Service Bulletin

FRONT / REAR STABILIZER NOISE PREVENTION

Bulletin No: 02-006/13

Last Issued: 11/25/2013

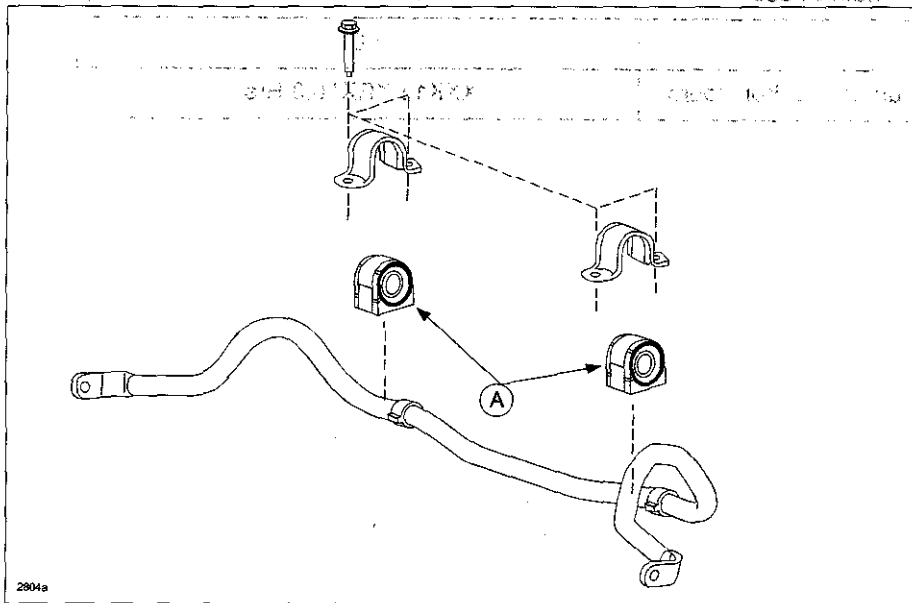
Beginning with the newer models (CX-5 and Mazda6), grip type front and rear stabilizer bushings (A) have been incorporated for noise prevention purposes. If any type of grease or lubrication is applied to the bushings, it may create noise due to bushing slippage (CX-5 front bushings shown below).

NOTE: To prevent noise from occurring, never apply any type of grease or lubrication to the front or rear stabilizer bushings.
